Executive Director's Recommendation

Commission Meeting: July 7, 2016

PROJECT Building Exterior, Vestibules and Site Improvements National Air and Space Museum The National Mall Washington, DC	NCPC FILE NUMBER 7585
SUBMITTED BY Smithsonian Institution	NCPC MAP FILE NUMBER 1.41(38.00)44186
REVIEW AUTHORITY Federal Projects in the District per 40 U.S.C. § 8722(b)(1) and (d)	APPLICANT'S REQUEST Approval of comments on concept design
	PROPOSED ACTION Approve comments as requested
	ACTION ITEM TYPE Staff Presentation

Terrace Improvements: Perimeter Security

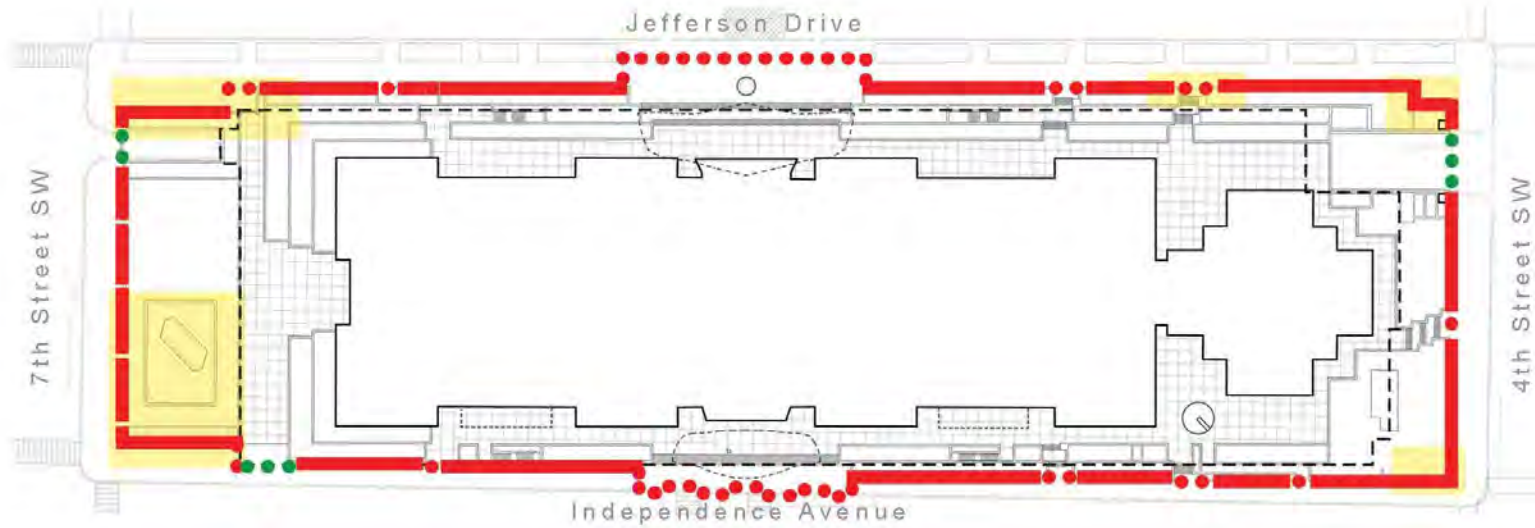
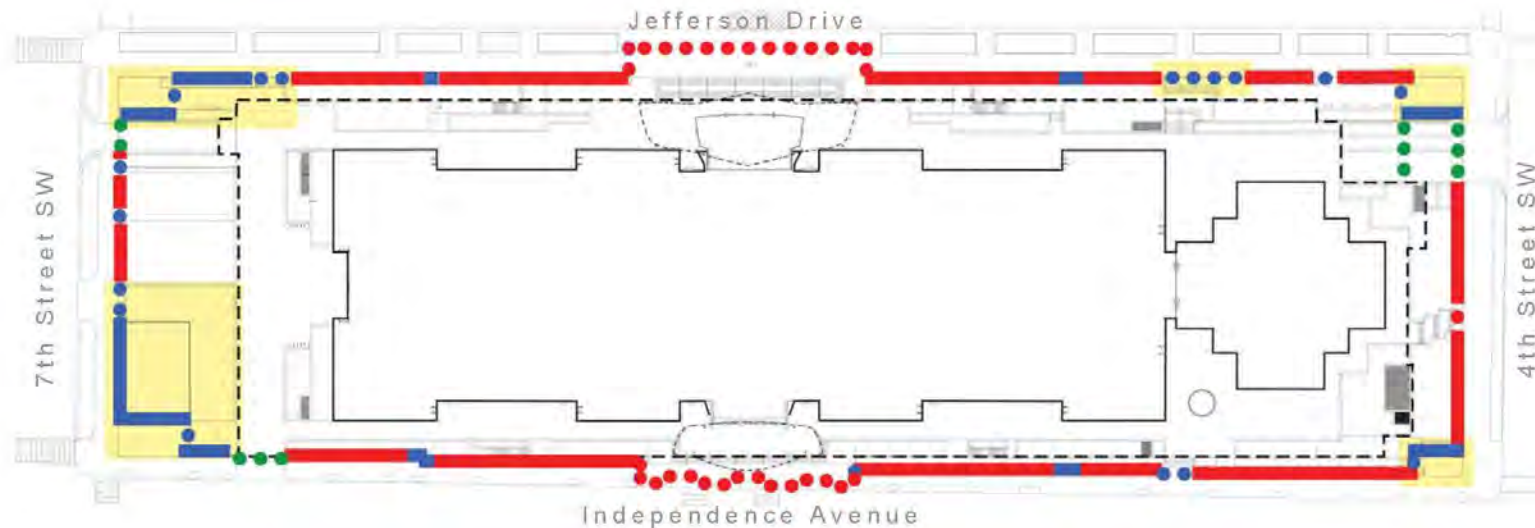
However, there are some issues with the existing perimeter security: the terrace walls are too high, the jogging bollards at the south entry along the Independence Avenue sidewalk clutter the public space, and the location of bollards at the west corners interrupt pedestrian circulation.

- Remove or adjust proposed bollards within planting bed areas at corner conditions to achieve a better transition between different security elements, avoid conflicts with landscape and ease maintenance.

- Ensure that the proposed perimeter security is consistent with the existing *Mall-Wide Perimeter Security* plan previously approved by the Commission and is compatible with the placement of security barriers for other buildings along the National Mall.

Terrace Improvements: Proposed Site Plan – Scheme A and B

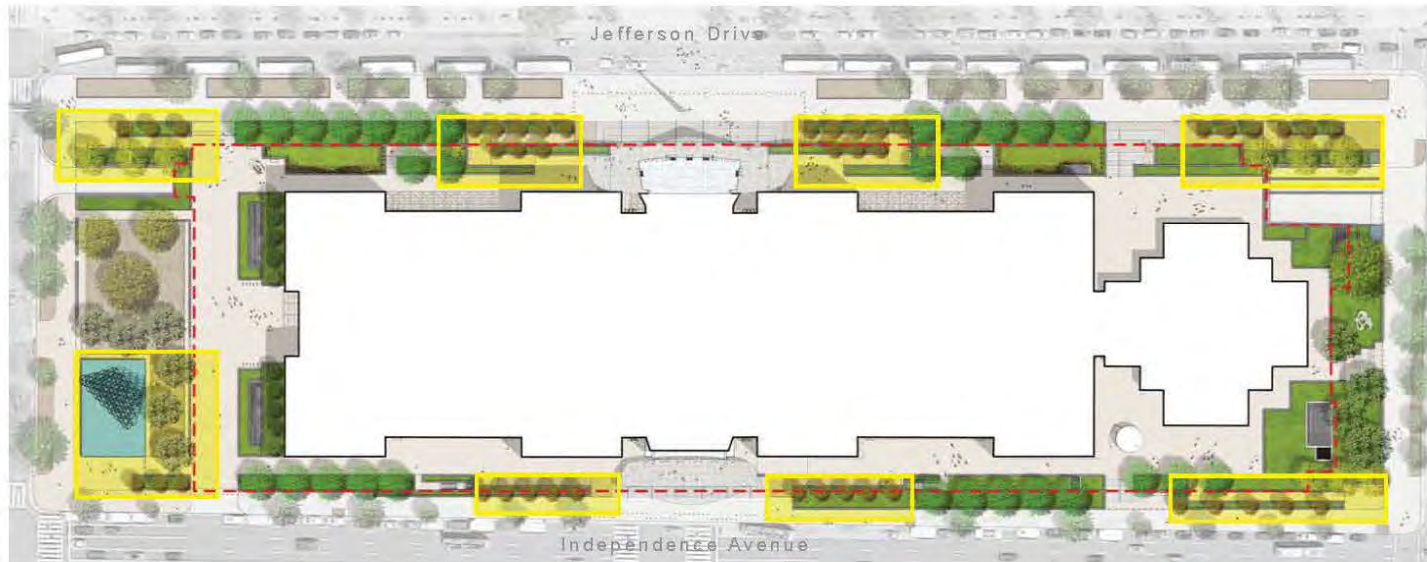
Supports *Scheme A: Ground Plane* option (Smithsonian Preferred Alternative), because this scheme better achieves the terrace improvement design objectives, in addition:

- Creates a welcoming, and inviting public space for people.
- Provides a balanced transition between building massing, landscape and human scale.
- Minimizes solid walls by eliminating planters and providing ground level planting beds which improves public safety and visibility.
- Accommodates wider walkways, which enhances circulation and creates a sense of openness.
- Provides shade canopy trees by accommodating adequate soil volume and extended root zones.
- Enhances view corridors between the museum grounds and the National Mall.

Does not support *Scheme B: Planter* option, which proposes a raised planter system that follows the “building sitting on a plinth” architectural vocabulary because the design:

- Creates narrower walkways, with taller planters which obstructs visibility and affects circulation.
- Provides less shade by limiting soil volume which constrains plant selection to smaller species.

Terrace Improvements: Tree Canopy Plan

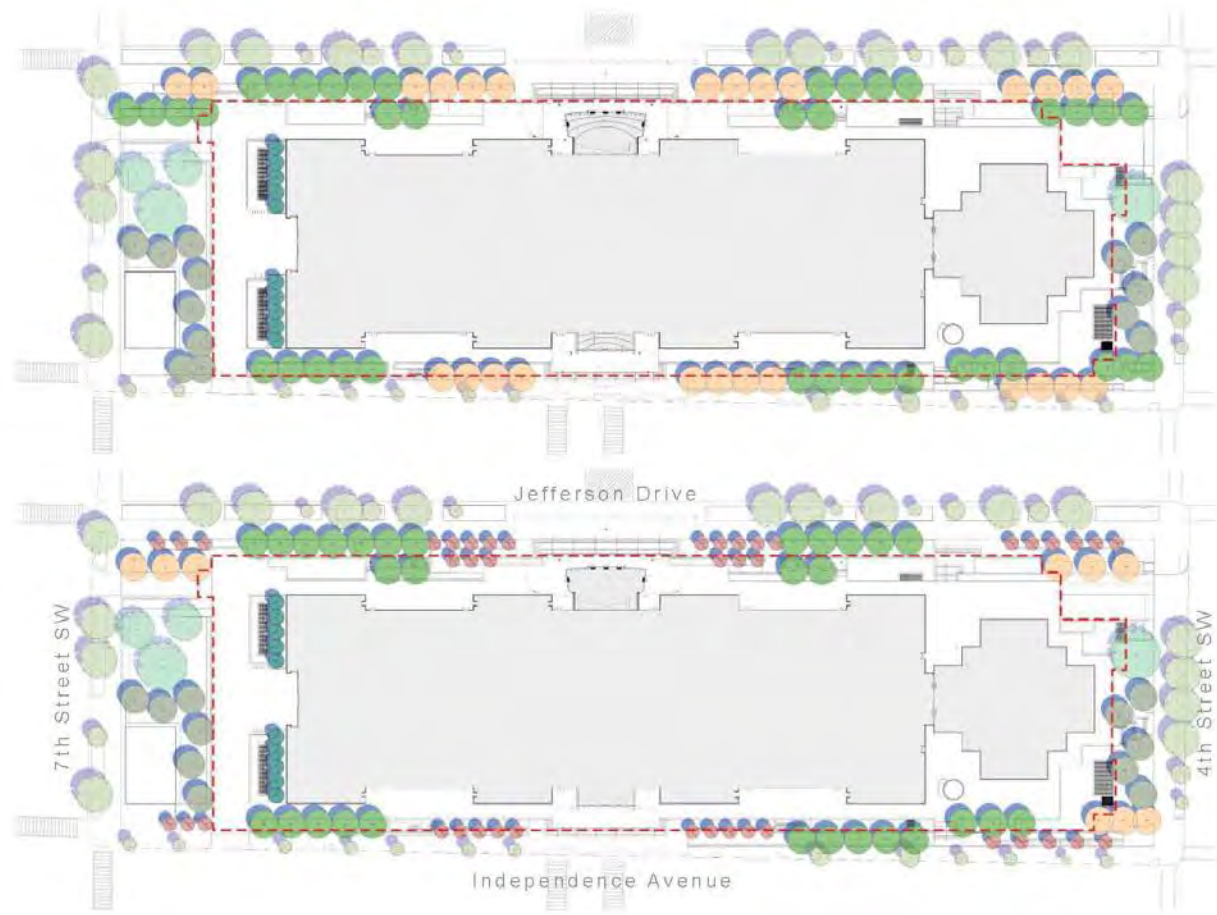
Human Comfort: In Scheme A, the proposed ground level planting beds increase planting soil volume to enable larger shade canopy trees by connecting covered soil areas under adjacent walkways to accommodate tree root growth. In contrast, Scheme B with the raised planter approach does not allow an extended planting soil under adjacent pavement. The tree planting soil area is raised above the paving approximately 36 inches. Since the majority of tree root growth occurs within the top 18 to 24 inches of soil depth, it is standard horticultural practice to only account for the first 3 feet of soil depth when assessing soil volume for trees. The raised planter wall height in Scheme B will constrain tree root growth and can only accommodate small trees. Therefore, Scheme B provides less shade.

Scale: The proposed shade trees included in *Scheme A* will blend with the existing American Elms trees that line the National Mall and provide a scale transition between building massing and human dimension. In contrast, the proposed small trees in *Scheme B* make the building look monumental and overshadows the human scale.
